MoDOT's I-70 Evaluation

Public Works Recommendations
September 6, 2022

Figure 4: Recommended Yellow Alternative

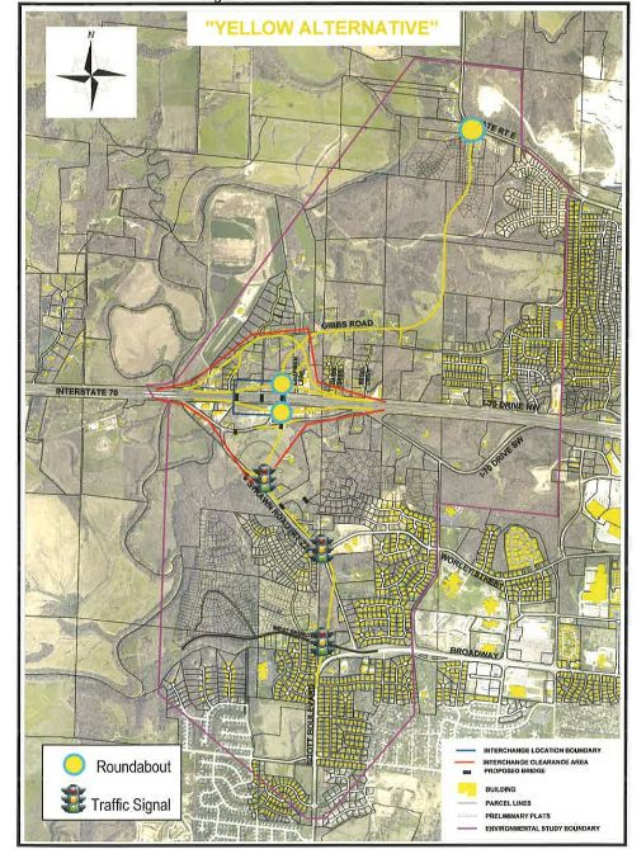
- Provides an outer road connection across Perche Creek and improves the existing outer road north of I-70
- 3 miles, 1 bridge
- Staff recommendation:
 - All proposals to date from MoDOT have appeared to specifically avoid any possibility of construction of any aspect of the Scott Boulevard interchange. The City has an FHWA approved Access Justification Report (AJR) for the interchange. Providing another connection across Perche Creek is critical for long term emergency response for both the County and City. During periods of significant delay along I-70 due to construction or significant incidents, travelers often utilize UU (MoDOT) to Gillespie Bridge Road (County and City) to Scott Boulevard (City) to access other routes around the incident backup. While relatively rare, the additional vehicle loads on City streets accelerates deterioration as well as impacting travel during those times. Another connection across Perche at this location should be a critical component of an improvement project in order for travelers on the Federal system to be able to stay on the federal system during periodic construction or incidents. The improvement should align with the findings of the AJR (see next slide, recommended AJR alternative). Another crossing of Perche is in MoDOT's Tier 3 Unfunded Needs list (page 35):

ALTERNATIVE 3
163-763
MINOR CD SYSTEM

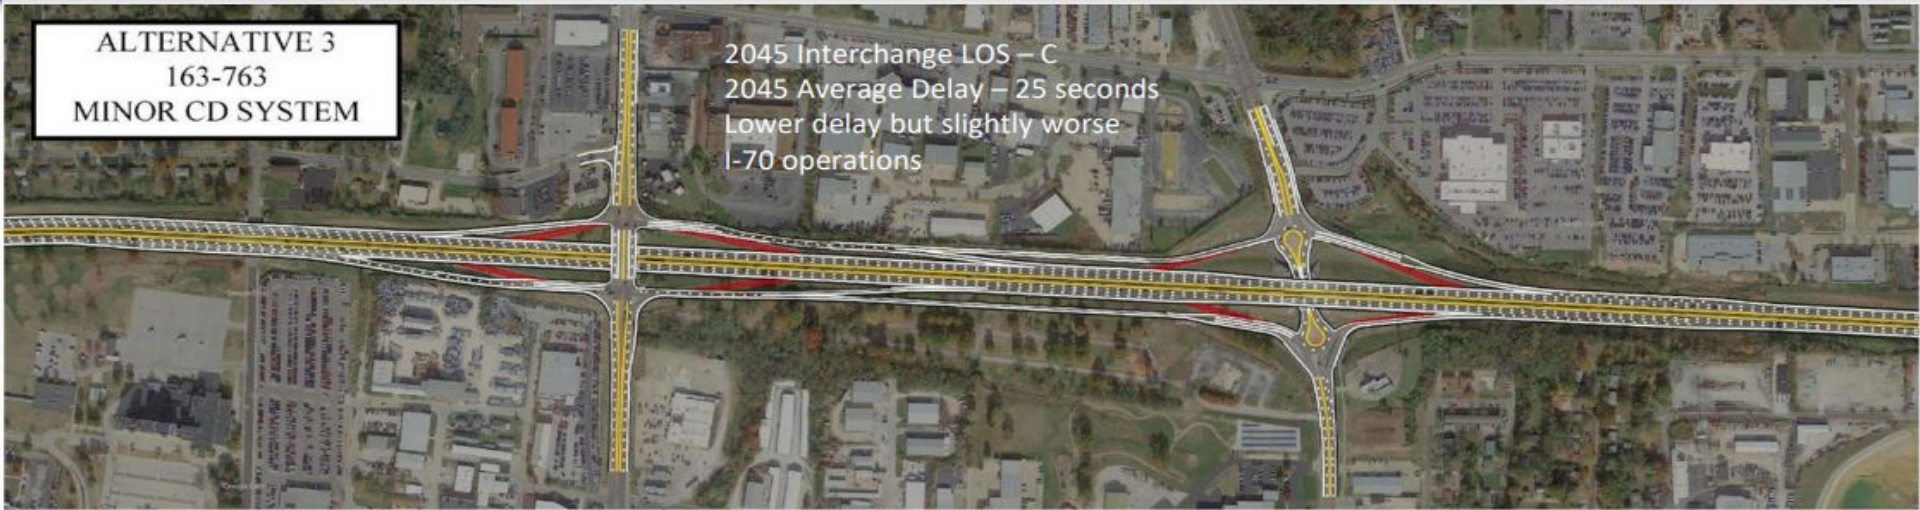
- Provides collector/distributor roads between Providence and Rangeline. The westbound off ramps and eastbound on ramps are combined, therefore Rangeline traffic to/from the west must go through the signals at Providence.
- The Loop CID's recommendation: "We do not support the addition of the north and south outer roads between Providence and Rangeline, nor the proposal to limit immediate access from I-70 to Rangeline (or vice versa). We don't believe the drivers should be redirected to the signal at Providence."
- Staff recommendation: What is proposed is consistent with access management best practices used throughout the federal highway system provided it also addresses non-motorized transportation needs.

I-70/US 63 Connector (Alternative 1)

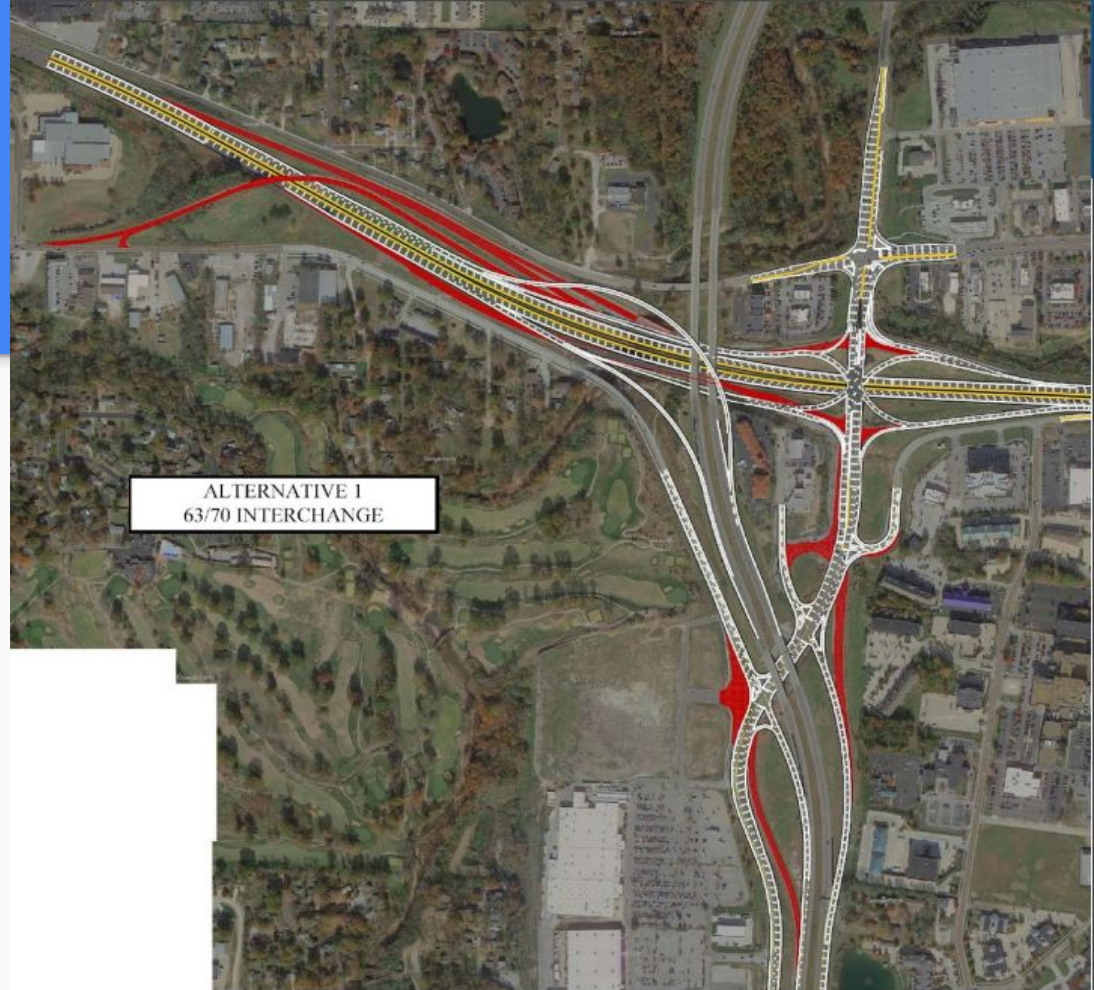
- The Loop CID's recommendation: "We will continue to review the proposals for the I-70/63 connector but again, we support long-term solutions here as well as strengthening other existing alternatives in order to relieve traffic along I-70. We would support an option that required removal of the left off ramp from I-70, especially if the Parker addition was an option.

- Staff recommendations:
 - The most recent iteration of preferred alternatives removes a signal from the City's maintenance, but creates several potential issues for City properties and roadways. It eliminates an organized entry/exit (the signal) to the Broadway Marketplace location without sufficiently addressing the volumes entering and exiting the retail location. There is no shown improvement as part of the project either north or south of the location that provides for protected left turns into or out of the shopping center. This must be addressed as part of the project.

- Staff would request that any design and eventual construction improvements to the I-70/US 63 connector include the Hinkson Creek Trail extension as it is a critical piece of non-motorized transportation to connect Columbia citizens on the north and south side of I-70. The planned route for the trail may no longer be viable depending on the selected plan for roadway improvements so Parks & Recreation staff would request to be involved with planning discussions once the roadway option is selected for the interchange. The extension of the trail is a key piece of the 30-mile trail loop through Columbia and is considered a critical connection for cyclists and pedestrians to navigate the I-70/US 63 interchange. Any improvement should directly accommodate pedestrian and cycling traffic to and through intersections per FHWA's Complete Streets Model.

Exhibit S-1 Preferred Alternative

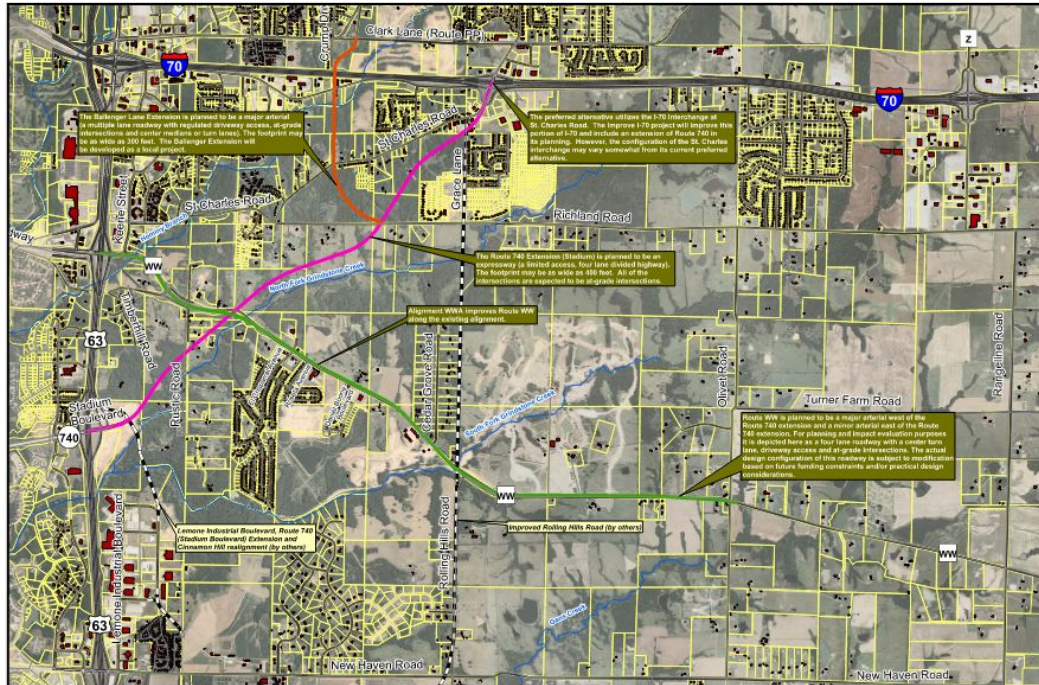
- The East Columbia Environmental Impact Statement (EIS), completed in 2009, should be updated. This will help determine long term transportation improvement needs east of US 63 including major interchange and overpass improvements for I-70. Funding for a portion of Stadium (US 63 to Route WW) is listed in Tier 3 for MoDOT's Unfunded Needs list (page 35):
<https://www.modot.org/sites/default/files/documents/2022-01%20FINAL%20High-Priority%20Unfunded%20Needs.pdf>.

St. Charles/Lake of the Woods

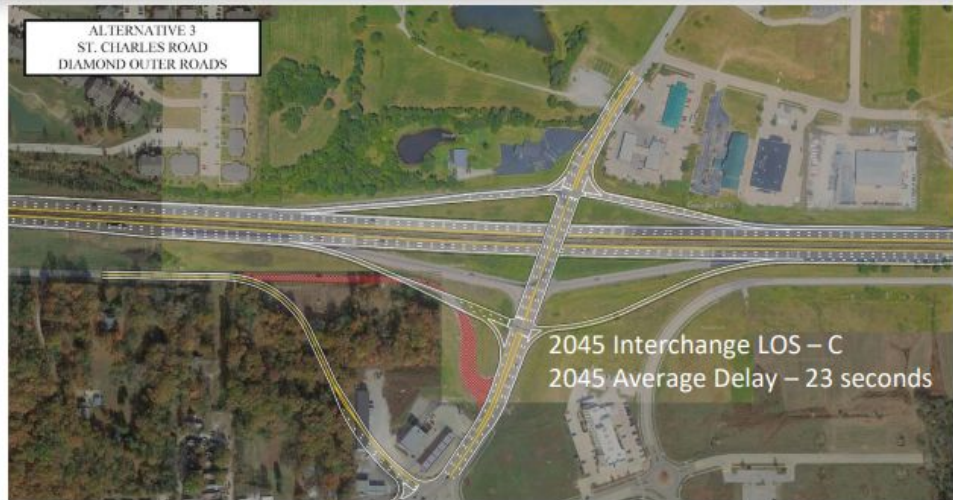
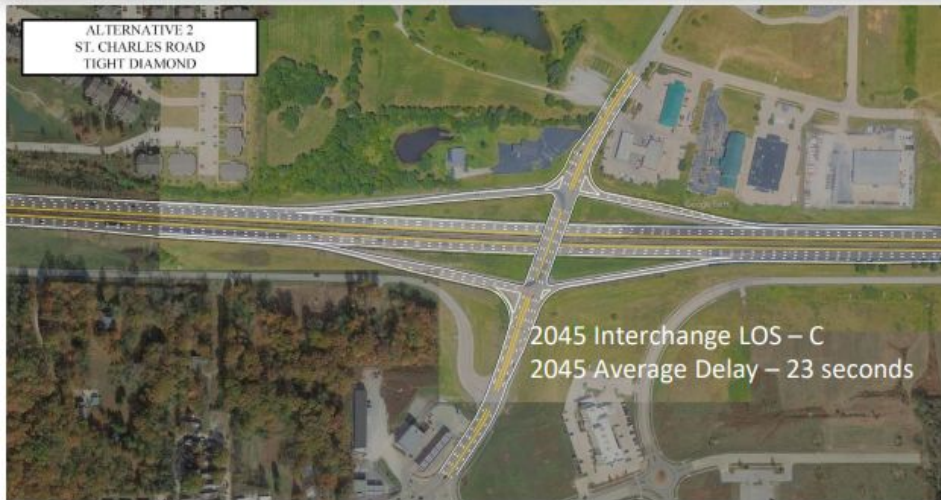
- The Loop CID's recommendation: "St. Charles/Lake of the Woods interchange should be improved and coupled with a plan to complete the extension of Stadium Boulevard from its existing terminus at Highway 63 to the improved St. Charles/Lake of the Woods interchange. This alternative provides the most effective way to relieve traffic at the I-70/Highway 63 intersection."

- Alternative 2 replaces and widens the overpass for additional lanes.
 - Staff recommendation: Staff recommends that the East Columbia EIS be updated. This will provide the best information about how Stadium and other roadways and interchanges should be improved.

- Alternative 3 replaces and widens the overpass for additional lanes and relocates the eastbound ramps and south outer road.
 - Staff recommendation: Staff recommends that the East Columbia EIS be updated. This will provide the best information about how Stadium and other roadways and interchanges should be improved.
